Responses to Open Items
Related to the License Amendment Request for the
Upgrade of the Instrumentation and Control System
for the
Armed Forces Radiobiology Research Institute
TRIGA Reactor

7 January 2022

The following are responses to open items from the on-going audit in support of the Digital Instrumentation and Control System Upgrade for the AFRRI TRIGA Reactor (EPID L-2020-NFA-0012).

Figure 3-1 – Pulse Mode Functional Block Diagram for the Old AFRRRI Control Console.

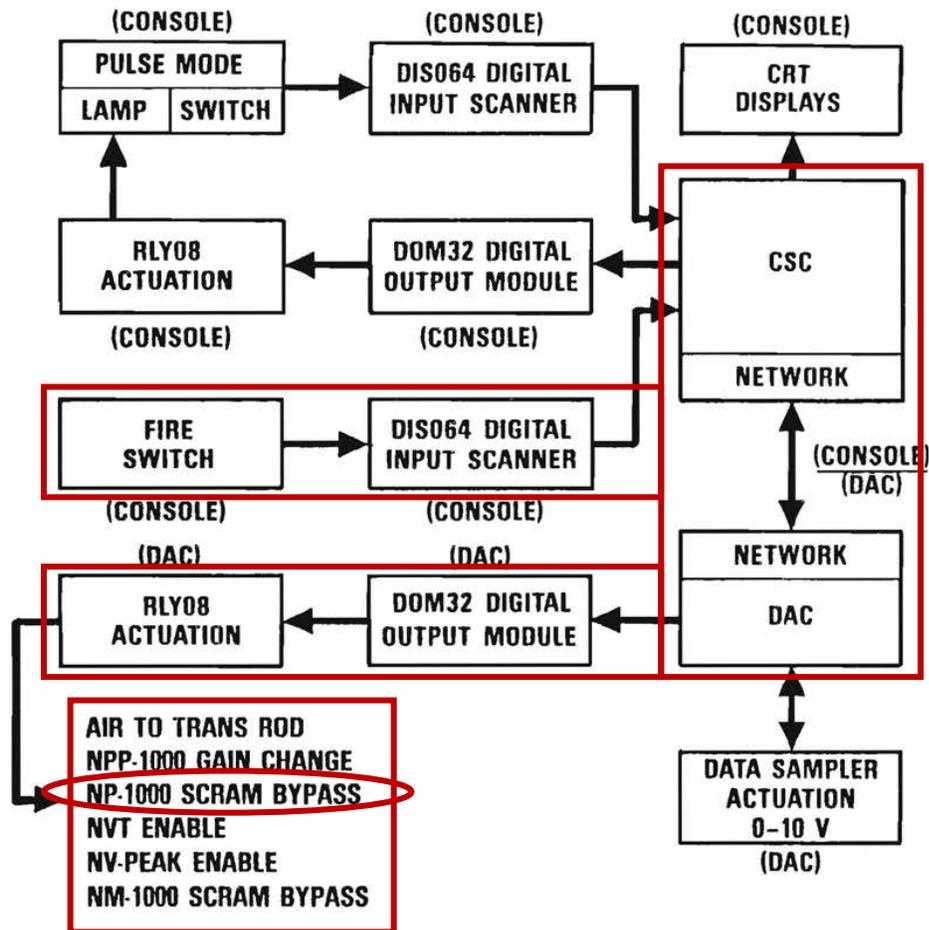
3. During a pulsing operation, an additional Inhibited field will be shown for the NLW and NMP channels and an additional Bypassed field will be shown for the NP channel in the control console. Describe what signals generate the Inhibited field signal?

The control console has always performed the bypass for the NP-1000 overpower scram during Pulse Mode operation. This software control has been maintained in the new control system. Refer to Figure 3-1 – Pulse Mode Functional Block Diagram for the Old AFRRRI Control Console which is from previous control console Operation and Maintenance Manual E117-1006, Figure 3-11.

These signals are generated by the control console computer. The sequence of events are (refer to Section 2.19 Pulse Mode of SAT 1 (page 67):

- Enter Pulse Mode.
- Press the FIRE pushbutton.
- Computer verifies that all conditions are satisfied (1 kW interlock, transient rod on bottom, etc.).

- The computer sends a signal to the to the NP (bypass the overpower scram), the NLW (disconnect the electrometer) and NMP (disconnect the electrometer); signal is sent to the NPP for gain adjustment during pulse.
- The console display will show the NP bypassed, NMP and NLW inhibited fields.
- The pulse occurs.
- The pulse timer scram occurs.
- The units automatically drop out of bypass/inhibited; NPP gain reverted.

Figure 7-1 – Ranges of Operation for the NMP-1000

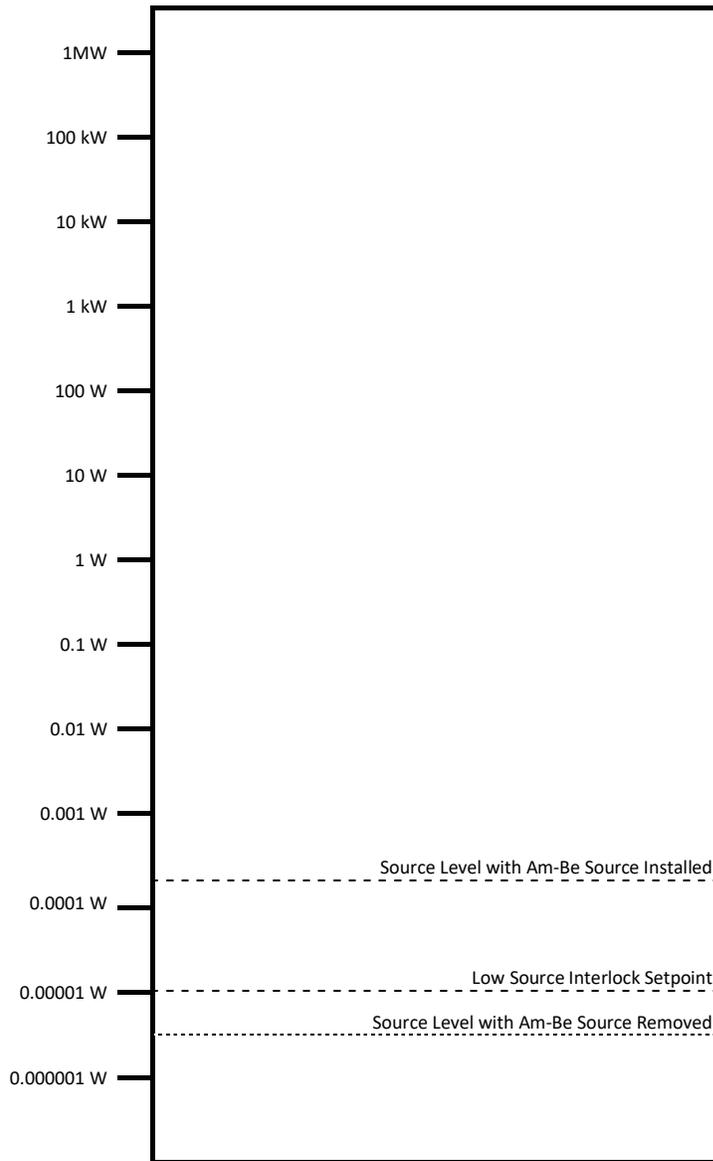
7. **In the LAR, AFRRRI proposed a Technical Specification change to replace the setpoint for the rod withdrawal interlock for the NMP-1000. The modification would change the setpoint for the power level from <0.5 cps. to <1x10⁻⁵ watts. Explain whether these setpoints are equivalent, and provide the calculation that shows this conversion.**

The design function of the low source interlock is to only permit rod withdrawal when there are sufficient neutrons to provide proper instrument response for bringing the reactor critical under controlled conditions. Therefore, it is only necessary to verify that the channel is capable of performing this design function. This is accomplished by using a neutron source to ensure that the channel is responding to neutrons and not just gammas. The neutron source used at AFRRRI is a 3 curie (Ci) americium-beryllium (Am-Be), cylindrical-shaped, double encapsulated source. The source is located in the core, and remains there during operation, but can be removed for training, maintenance, and to verify the functionality of the source interlock.

During the functionality test, the source is removed from its normal in core location and the power monitoring instrument, NMP-1000, is allowed to drop below the interlock setpoint which trips the rod withdraw interlock and prohibits the withdrawal of control rods. This test ensures that the interlock is set properly.

From Figure 7-1, it is shown that a setpoint of 1×10^{-5} watts is well above the level when the source is removed which provides assurance that channel is operating correctly by detecting sufficient source neutron prior to startup. Therefore, it is concluded that the proposed change to Table 3 of TS 3.2.2 for the source range interlock will continue to perform the design function required by this channel.

Figure 5-2 – Core Dolly Limit Switch Diagram

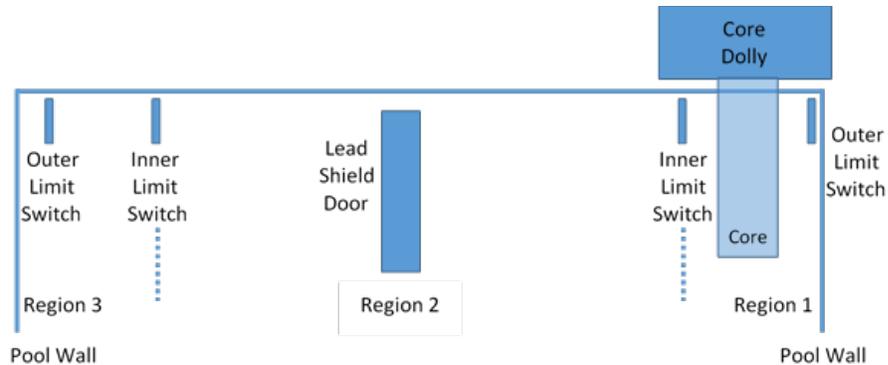
9. **Provide additional information to supplement Section 2.3 of LAR, Rev. 1, regarding the operation of the dolly switch.**

For each region there are two limit switches that will stop core dolly movement - the inner and outer limit switches. Refer to Figure 5-2 for a diagram of the switches. The outer limit switch stops the core dolly when it reaches the far end of the travel to prevent contacting the pool liner. The outer switches cannot be overridden. To prevent contact with the lead shield doors, the inner limit switch stops the core dolly from further movement if the lead shield doors are not fully opened.

For example, take the scenario of the operator moving the core dolly toward region 3 with the lead door closed. Once the core dolly comes off of the inner limit switch (switch is now open) the core dolly will stop and further movement of the core dolly is prohibited, this includes movement back toward region 1. Originally, the only way to recover from this scenario was to manually actuate the switch. This was accomplished by inserting a finger through a cutout in the core dolly rail and pushing down on the lever arm of the switch. Refer to Figure 5-3 below.
